NORTHEAST UTILITIES

Docket No. 50-423
B10845

References: (1) B. J. Youngblood to W. G. Counsil, Request for Additional Information for Millstone Nuclear Power Station, Unit No. 3, dated, May 3, 1983.

Millstone Nuclear Power Station, Unit No. 3:
Response to Select Requests for Additional Information

FIGURE 3.8-64 (1 OF 4)
CONTROL BUILDING
MILLSTONE NUCLEAR POWER STATION
UNIT 3
FINAL SAFETY ANALYSIS REPORT

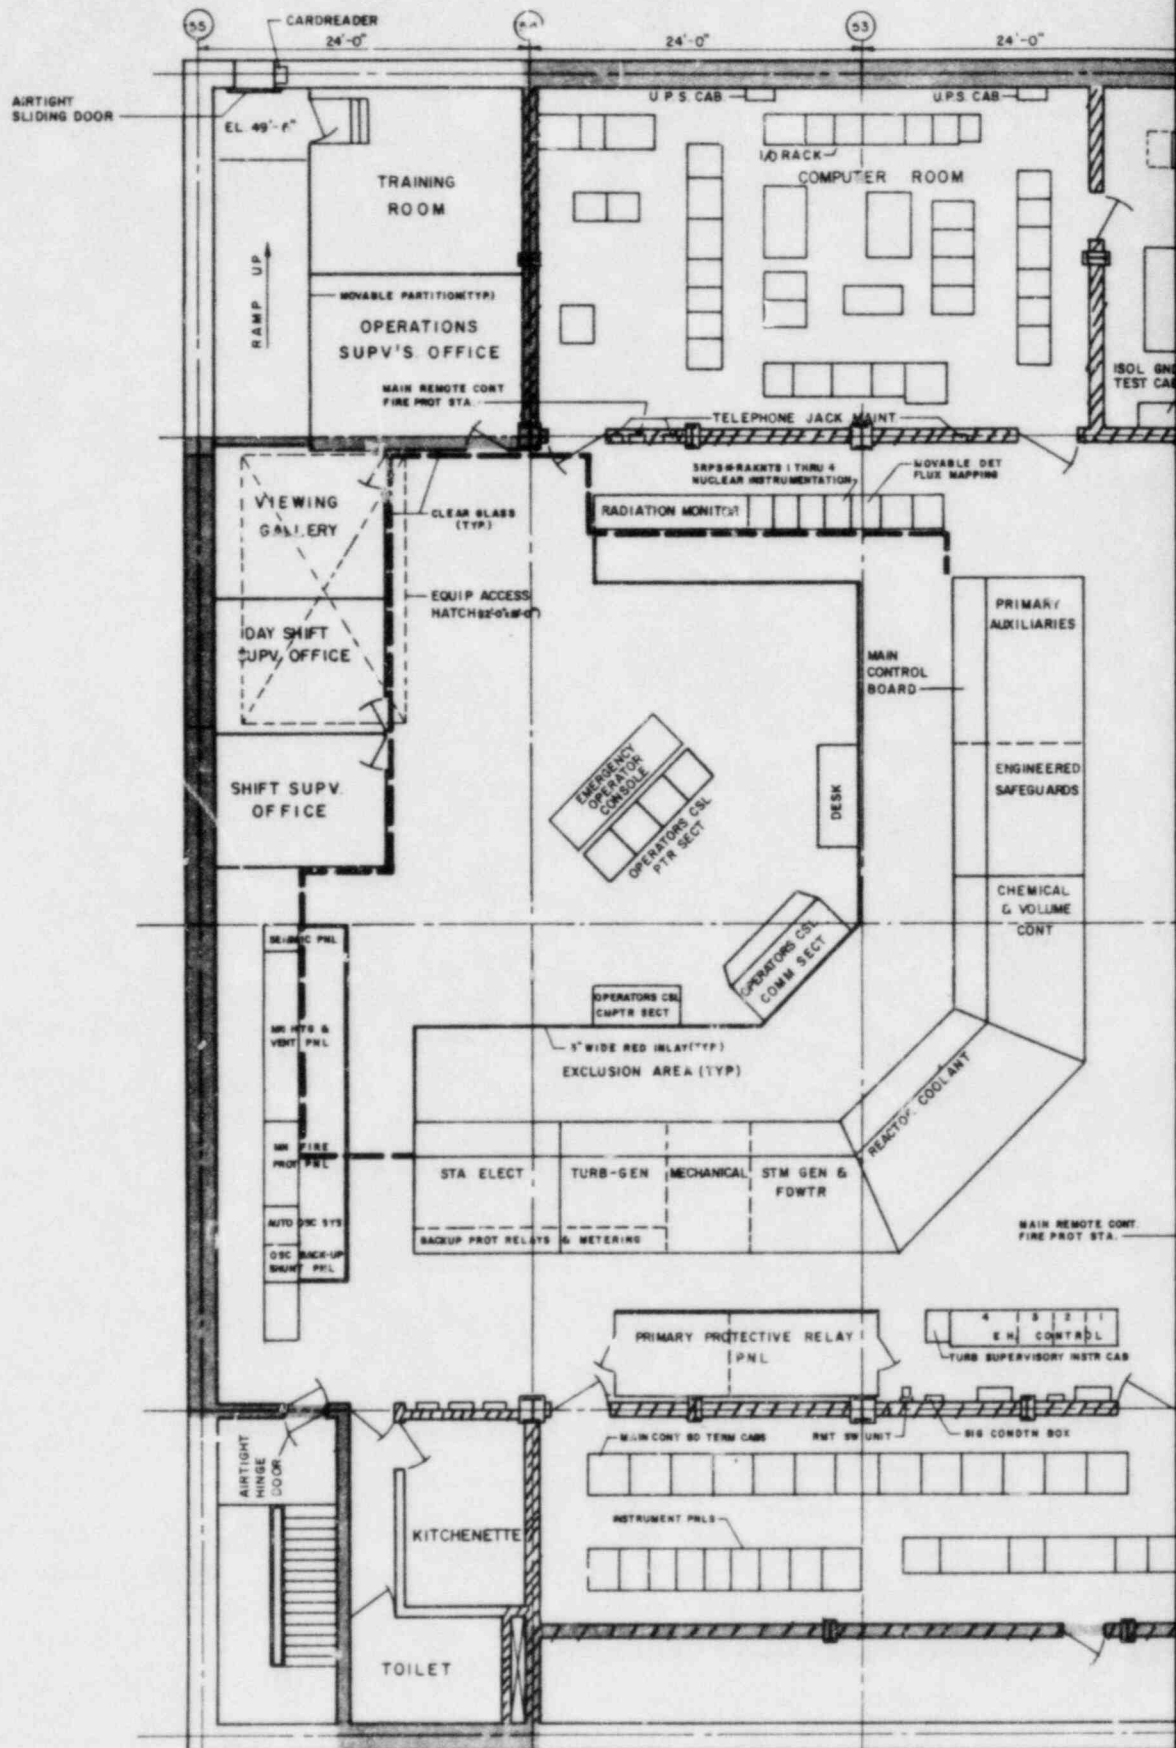
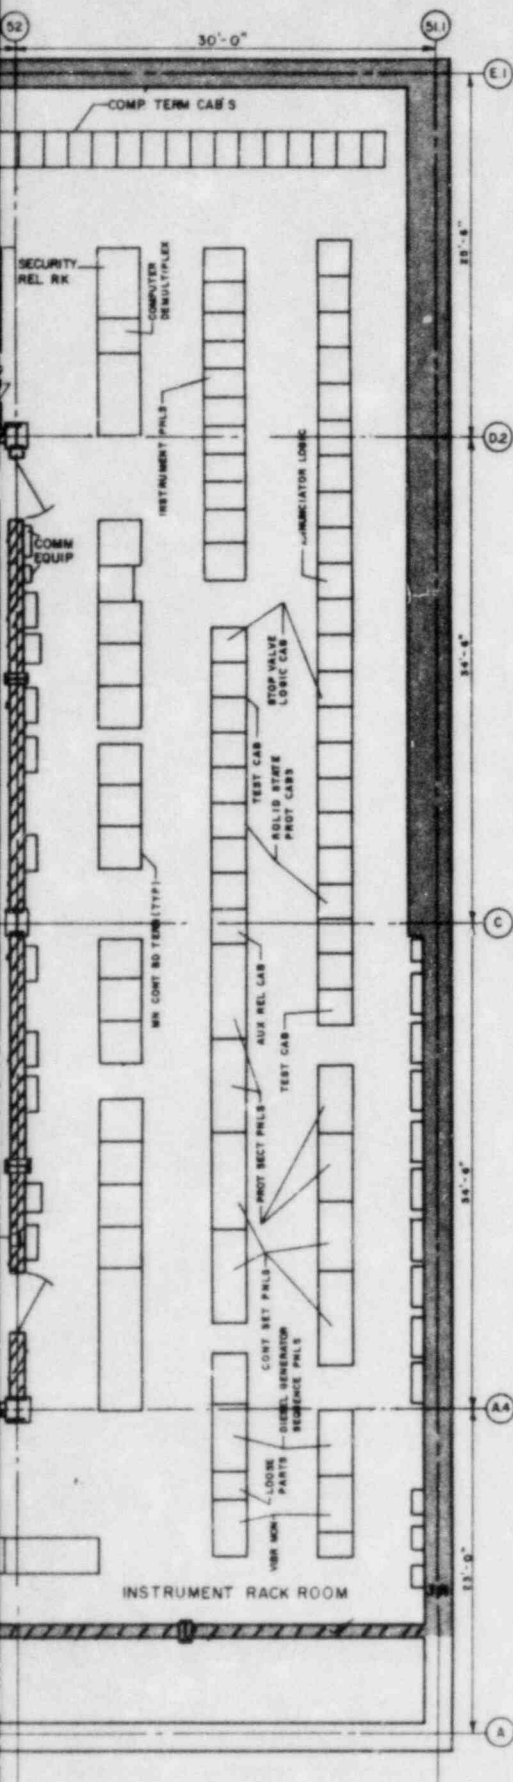
Are any safety related masonry walls in the plant? If yes, revise the FSAR to comply with the requirements in Appendix A to SRP Section 3.8.4.

Refer to revised FSAR Section 3.8.4.8 for the response to this question.

Masonry walls in safety related areas in the plant comply with the requirements in Appendix A to SRP Section 3.8.4. Locations of walls are given in Figure 3.8-64, Sheet 1 and 3.

FIGURE 2.5.4-43

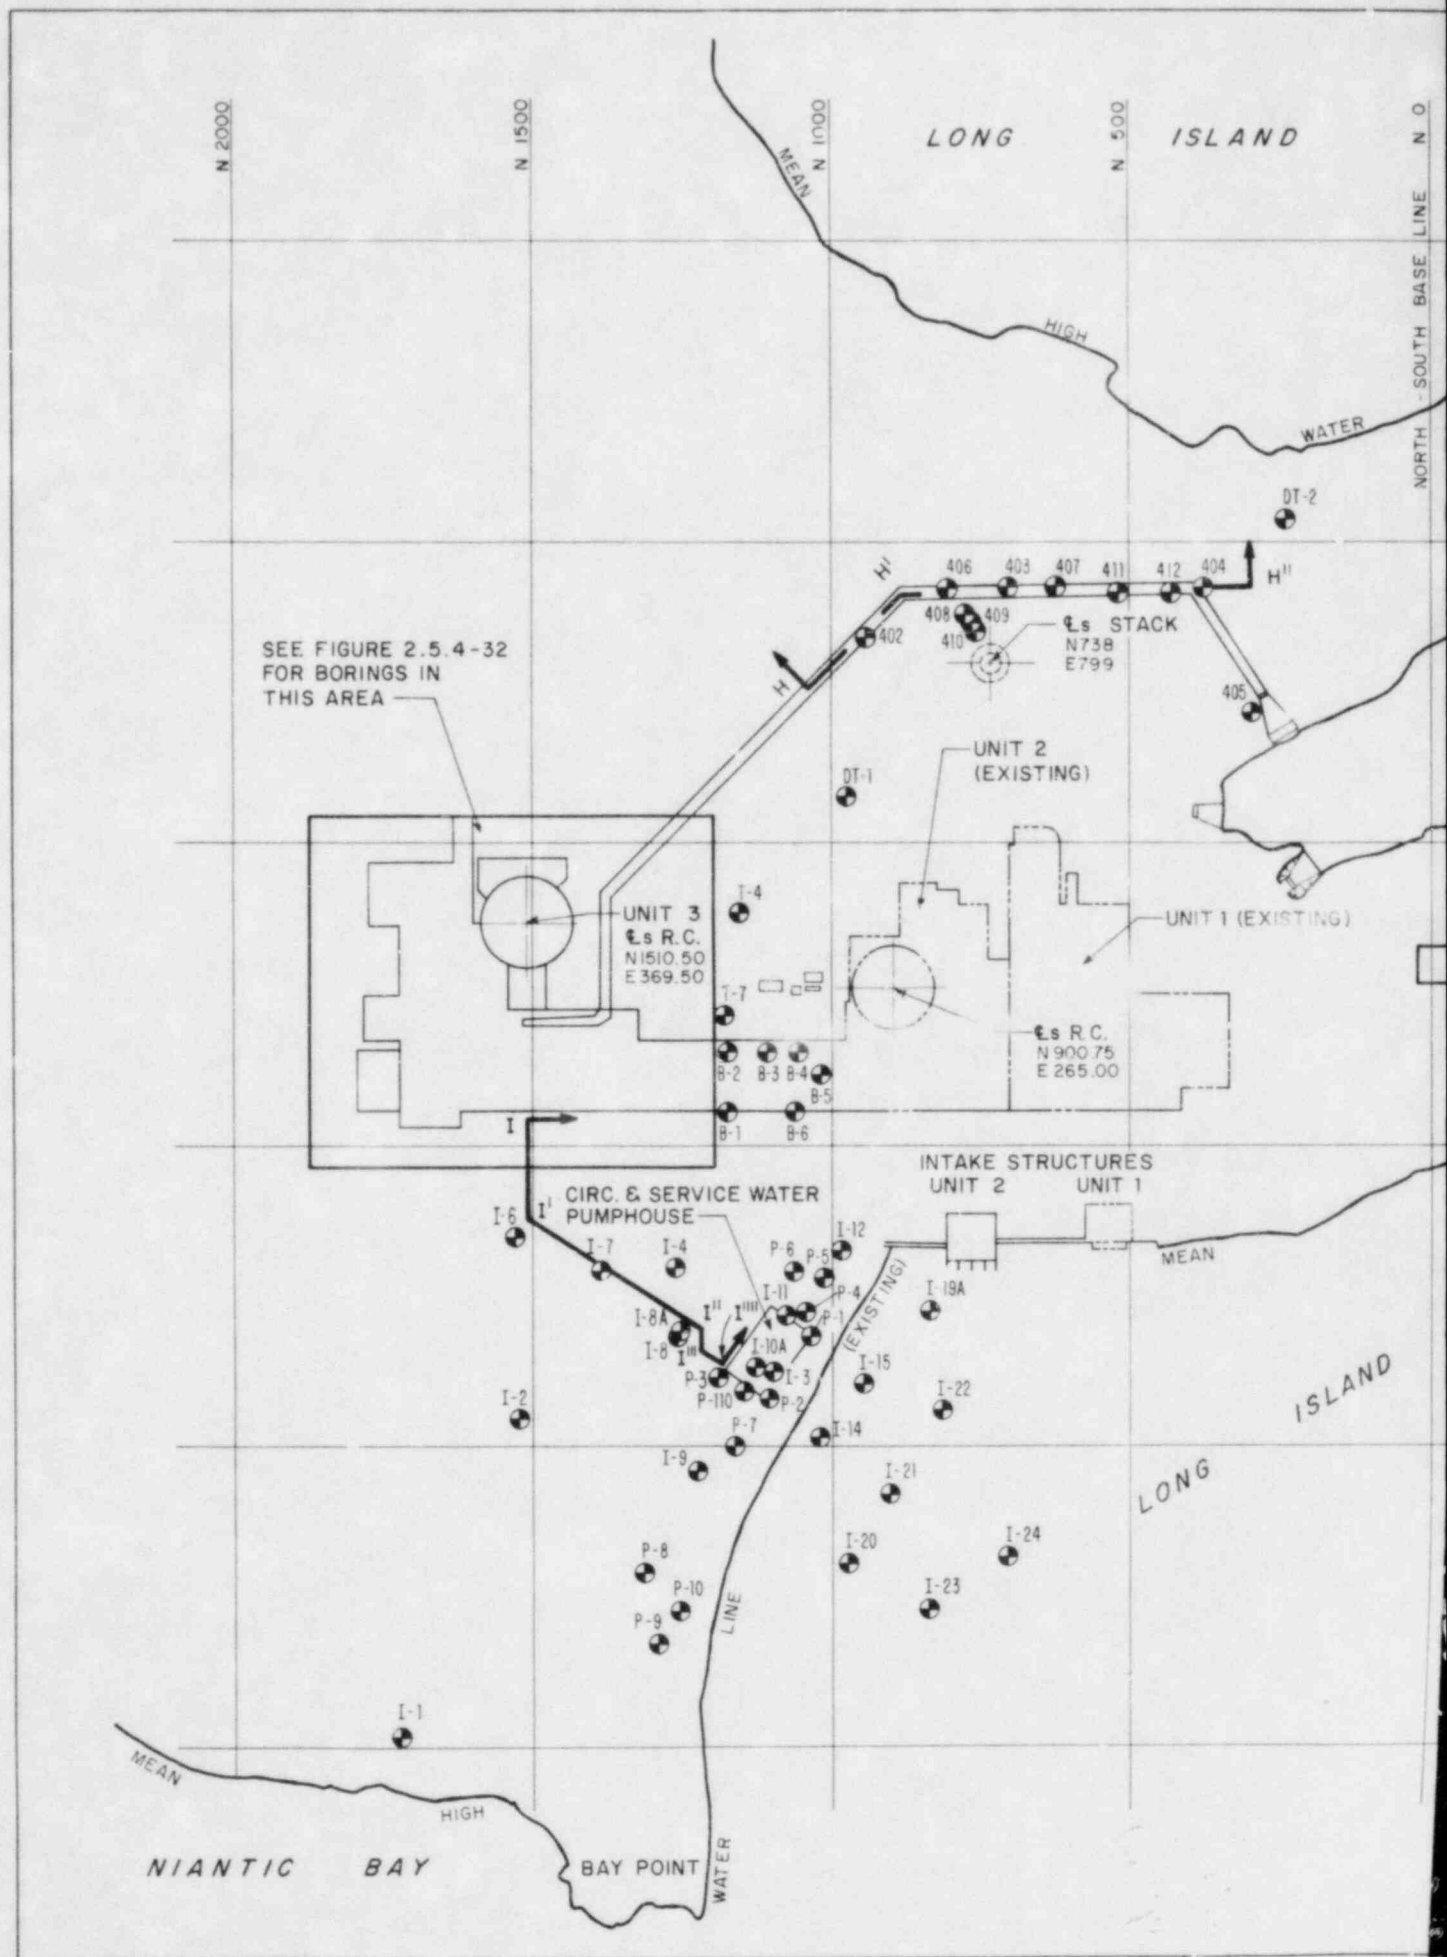
Question No. Q241.16 (Section 2.5.4.10.3 and SRP Section 2.5.4)

FSAR Figure 2.5.4-43 shows the lateral pressure distribution used in designing rigid unyielding foundation walls. The figure has been revised to correct errors and to add the unit weight of backfill. Also, FSAR Section 2.5.4.10.3 has been changed to correct typographical errors.

FIGURE 8.3-4
POWER SUPPLY
THIRD CHARGING PUMP
MILLSTONE NUCLEAR POWER STATION
UNIT 3
FINAL SAFETY ANALYSIS REPORT

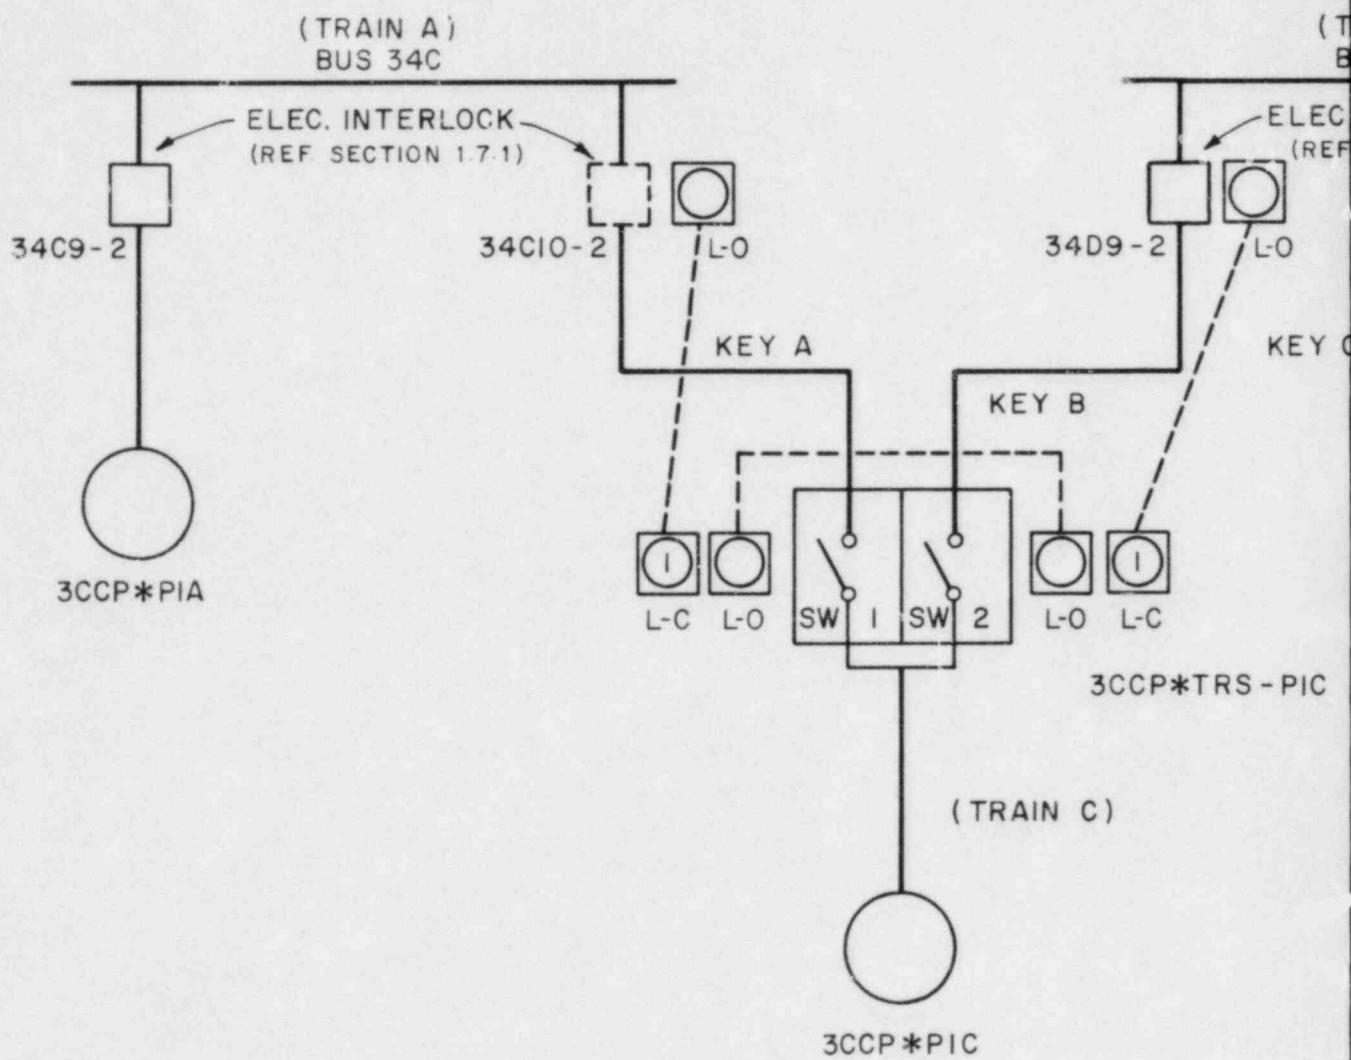
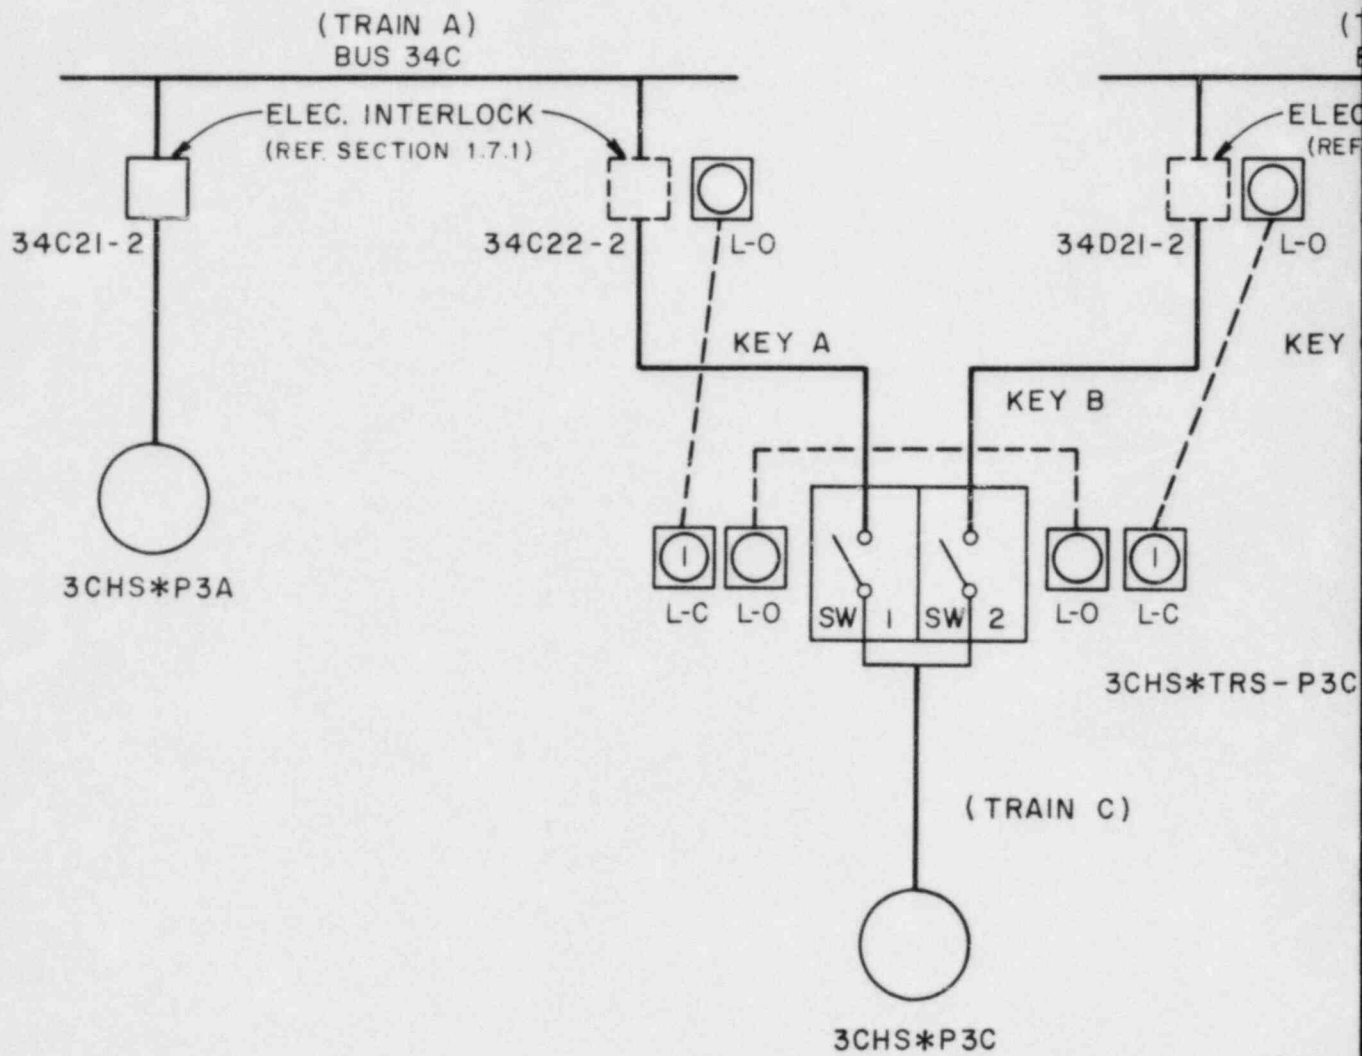
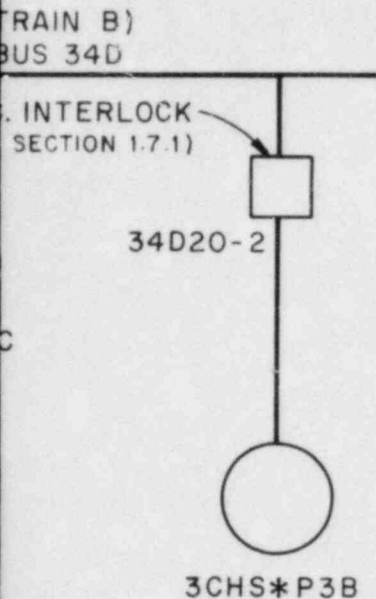
Question No. Q430.31 (SRP Sections 8.3.1 and 8.3.2)

Refer to revised FSAR Section 8.3.1.1.2 and revised FSAR Figures 8.3-4 and 8.3-5 for the response to this question.

Power for running the third charging pump is supplied from either emergency bus 34C (Train A) or 34D (Train B) (Figures 8.1-1 and 8.3-4). A manually operated transfer switch is provided to connect the pump to the selected bus. A feeder breaker cubicle is provided on each bus for connection to the transfer switch. Normally, these breaker cubicles do not have a breaker installed. Upon failure of or due to required maintenance of one of the two connected charging pumps, its circuit breaker will be removed from its switchgear cubicle and installed in the switchgear cubicle in the same bus for the third pump. Interlocks are provided to ensure that only one of the third pump power sources can be energized at any one time. Thus, at no time can the two emergency buses be tied together. Additional interlocks are provided to ensure that only one pump on an emergency bus can be energized at any one time.
